## Proposal for a new 02 Series of Amendments to UN Regulation No. 160 (Event Data Recorder)

The text reproduced below was prepared by the expert from the International Organization of Motor Vehicle Manufacturers (OICA) to introduce the requirements of new verification procedures with transitional provisions to allow for necessary preparation time. The text is based on chapter 6 of the proposal by the IWG on EDR/DSSAD (see documents ECE/TRANS/WP.29/GRSG/2023/11 and ECE/TRANS/WP.29/GRSG/2023/15) and is marked in blue bold for new and blue strikethrough for deleted characters.

**Corridor +/- 10 Per Cent of the Full-Scale Range of the Accelerometer**

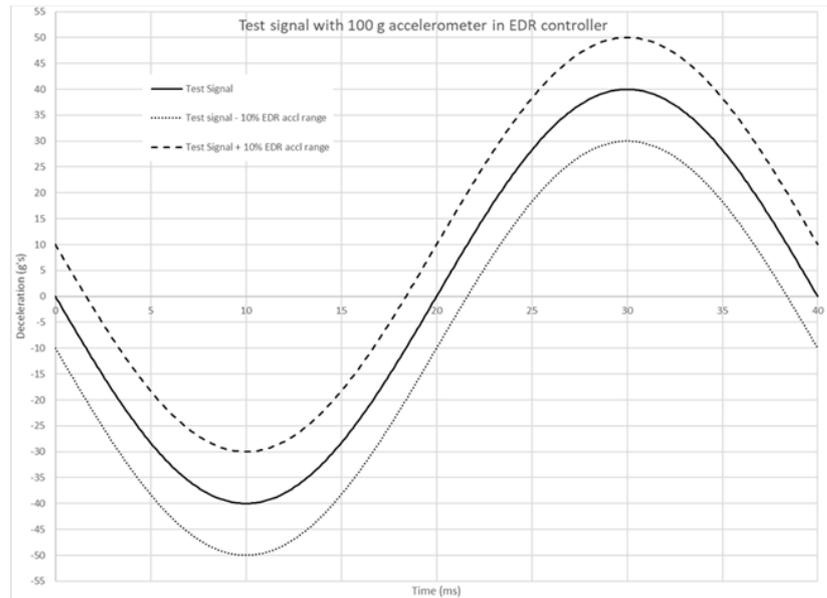
**6.1.5.** The EDR recorded acceleration trace shall be fully contained in a corridor that is +/- 10 per cent of the full-scale range of the accelerometer used by the controller containing the EDR applied to the component test fixture's filtered acceleration trace. The comparison of acceleration sensor traces shall only be made on the axis the component test was conducted.

For example, if the accelerometer in the controller containing the EDR function has a +/- 100 g range, then +/- 10 g would be applied to the component test fixture's filtered acceleration trace. The EDR recorded acceleration trace shall be fully contained within that corridor (see the Figure).
